## HISTORIC AND DESIGN REVIEW COMMISSION

May 05, 2021

**HDRC CASE NO:** 2021-193  
**ADDRESS:** 426 PIERCE  
**LEGAL DESCRIPTION:** NCB 1266 BLK 2 LOT N 120 FT OF 1  
**ZONING:** R-6, H  
**CITY COUNCIL DIST.:** 2  
**DISTRICT:** Government Hill Historic District  
**APPLICANT:** John Cunningham  
**OWNER:** John Cunningham  
**TYPE OF WORK:** Roof modifications  
**APPLICATION RECEIVED:** April 15, 2021  
**60-DAY REVIEW:** Not applicable due to City Council Emergency Orders  
**CASE MANAGER:** Huy Pham  
**REQUEST:**

1. Replace the existing rear shed roof addition with extruded gable addition and reclad with new smooth Hardie lap siding.
2. Perform a variety of fenestration replacement and relocation with new wood windows (Pella Lifestyle Series) and wood doors.

RIGHT SIDE ELEV. SCALE: 1/8" = 1'-0"

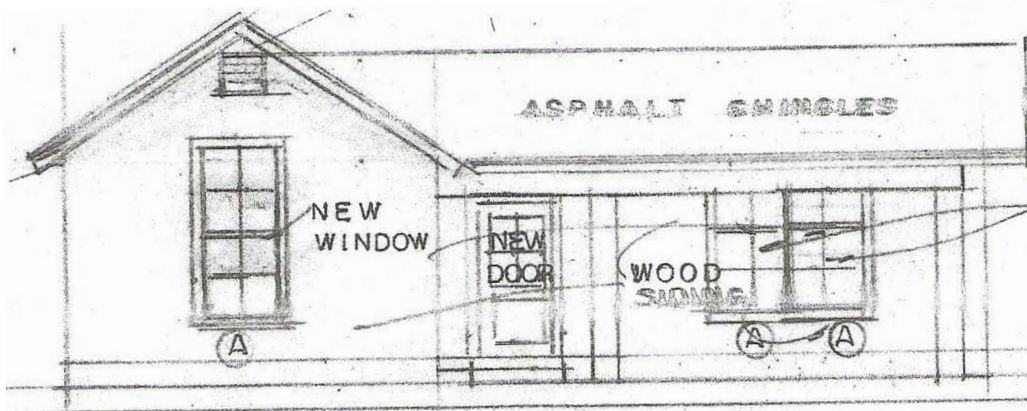
- b. ADDITION – The applicant has proposed to modify the shed roof of the rear addition to instead feature an extruded gable from historic roof form. The applicant has also proposed to reclad the new rear addition with 4” exposure, smooth Hardie lap siding and a vertical trim piece to distinguish between new and original forms. Per the Guidelines for Additions 1.A.iii., applicants should utilize a similar roof pitch, form, overhang, and orientation as the historic structure for additions; and 1.A.iv., applicants should utilize a setback or recessed area and a small change in detailing at the seam of the historic structure and new addition to provide a clear visual distinction between old and new building forms. Staff finds the proposed modifications are consistent with the Guidelines.

- Remove shed roof
- Extend existing gable
- Vertical trim piece between shed roof area and original house will be maintained, distinguishing the original structure
- Siding will be replaced with 4" non wood grain hardieplank cement siding

**REVISED FLOOR PLAN SCALE: 1/8"=1'-0"**

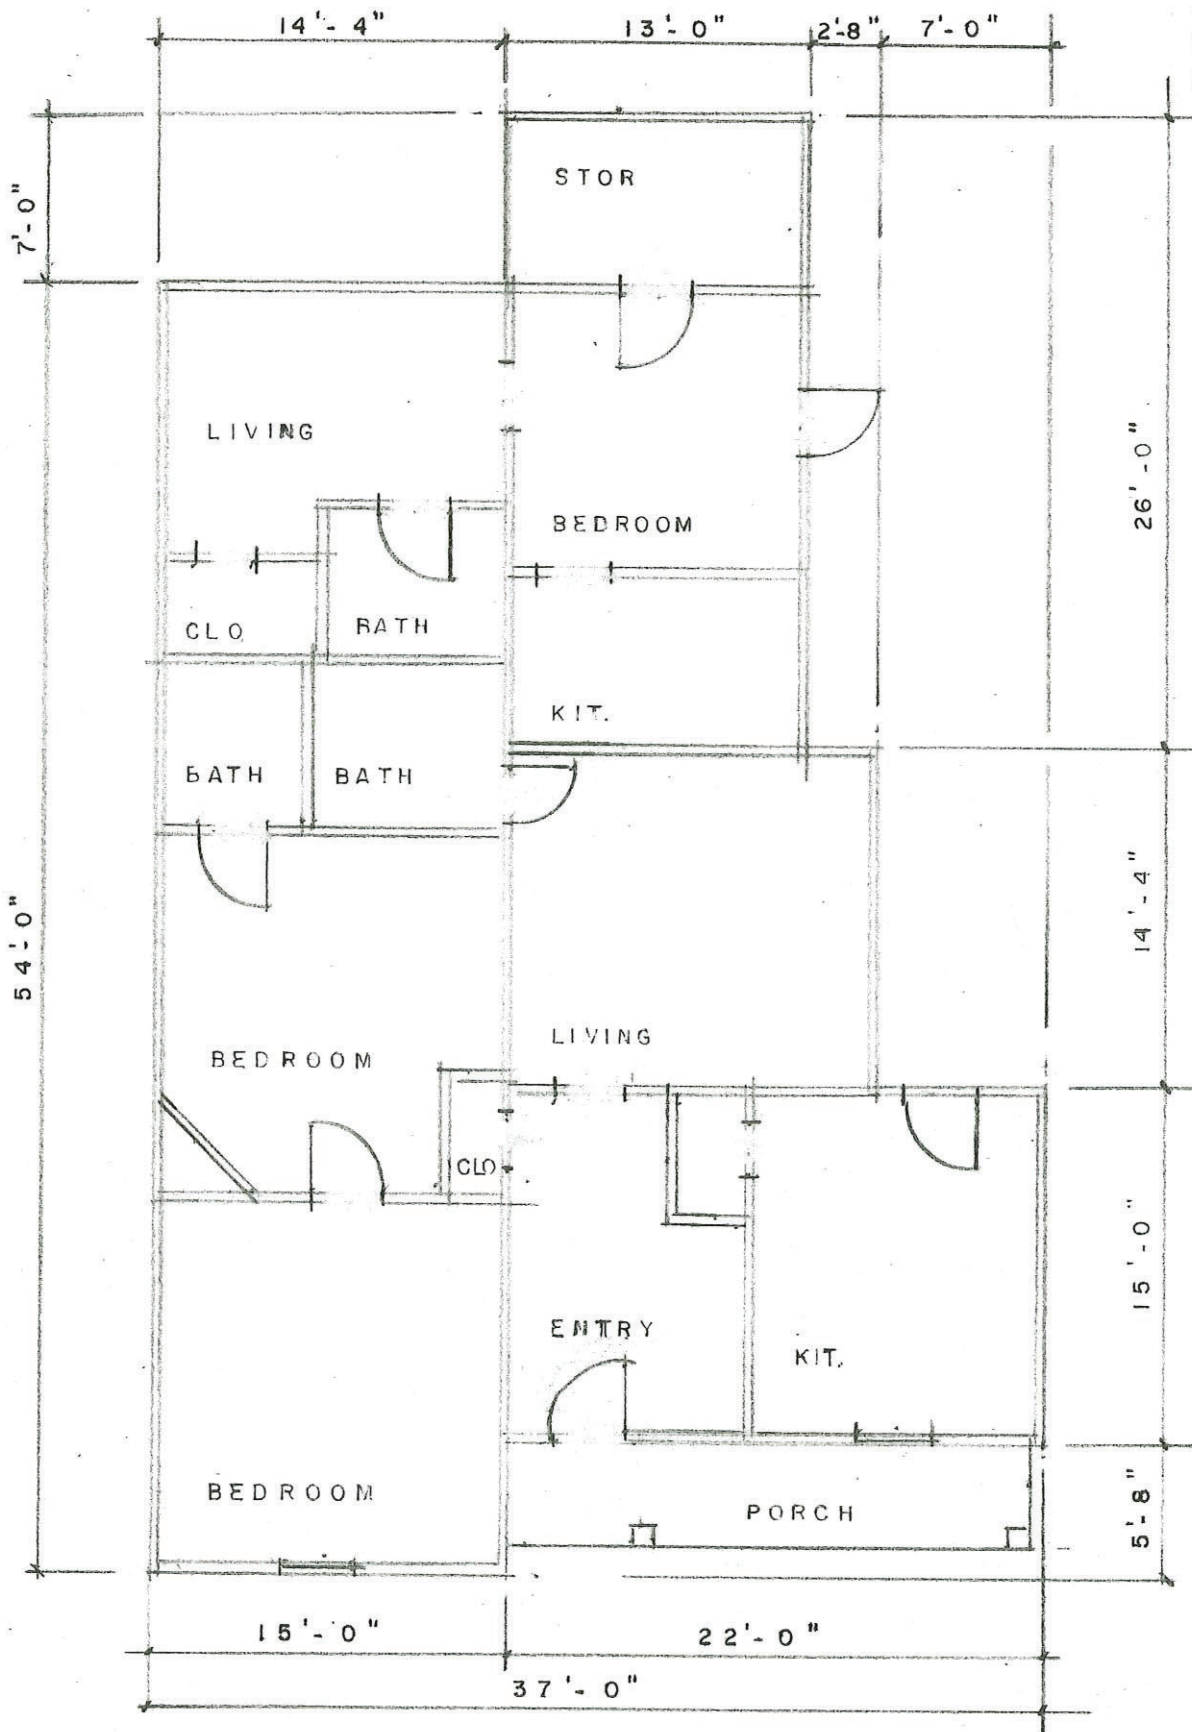
- c. FENESTRATION MODIFICATIONS – The applicant has proposed to perform a variety of fenestration replacement and relocation, primarily by restoring wood windows and placing them in more predominately visible window openings while installing new wood windows (Pella Lifestyle) and wood doors where they have been previously replaced or modified. Per the Guidelines for Exterior Maintenance and Alterations 6.A.i., applicants should preserve existing window and door openings, avoid enlarging or diminishing to fit stock sizes or air conditioning units, avoid filling in historic door or window openings, and avoid creating new primary entrances or window openings on the primary façade or where visible from the public right-of-way. Staff finds that the proposed scopes of work and the submitted elevation drawings of restored fenestration sizes, location, and configuration are consistent with the Guidelines and that the proposed window opening restoration is supported by the visible cut lines in the infill siding and typical historic fenestration patterns.
